PIC24FJ256GA110 Family Silicon Errata and Data Sheet Clarification

The PIC24FJ256GA110 family devices that you have received conform functionally to the current Device Data Sheet (DS39905D), except for the anomalies described in this document.

The following typographic corrections and clarifications are to be noted for the latest version of the device data sheet (DS39905D):

FIGURE 2-3 FREQUENCY vs. ESR PERFORMANCE FOR SUGGESTED VCAP

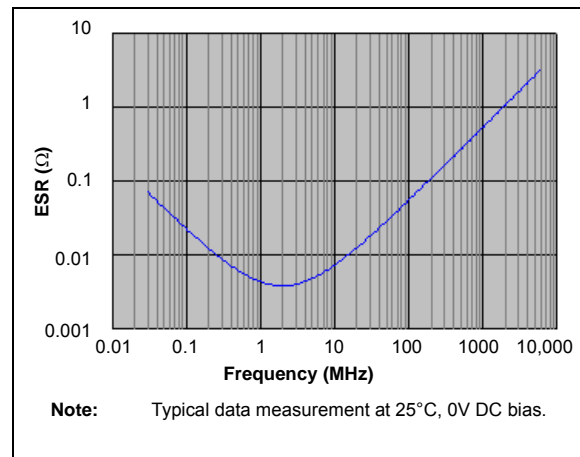
Section 2.4 Voltage Regulator Pins (ENVREG/DISVREG and VCAP/VDDCORE) has been replaced with a new and more detailed section. The entire text follows:

When the regulator is enabled, a low-ESR ($< 5\Omega$) capacitor is required on the VCAP/VDDCORE pin to stabilize the voltage regulator output voltage. The VCAP/VDDCORE pin must not be connected to VDD and must use a capacitor of 10 μF connected to ground. The type can be ceramic or tantalum. Suitable examples of capacitors are shown in [Table 2-1](#). Capacitors with equivalent specifications can be used.

Designers may use [Figure 2-3](#) to evaluate ESR equivalence of candidate devices.

FIGURE 2-4 DC BIAS VOLTAGE vs. CAPACITANCE CHARACTERISTICS

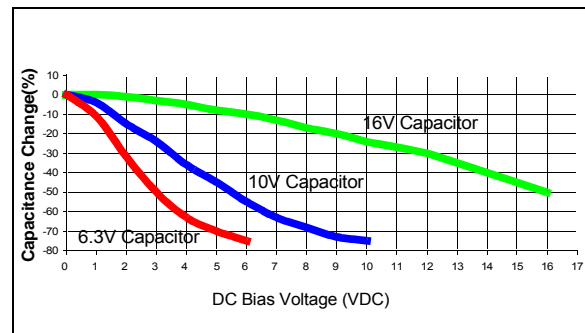
In addition to temperature tolerance, the effective capacitance of large value ceramic capacitors can vary substantially, based on the amount of DC voltage applied to the capacitor. This effect can be very significant, but is often overlooked or is not always documented.

A typical DC bias voltage vs. capacitance graph for 16V, 10V and 6.3V rated capacitors is shown in Figure 2-4.

When selecting a ceramic capacitor to be used with the internal voltage regulator, it is suggested to select a high-voltage rating, so that the operating voltage is a small percentage of the maximum rated capacitor voltage. For example, choose a ceramic capacitor rated at 16V for the 2.5V core voltage. Suggested capacitors are shown in Table 2-1.
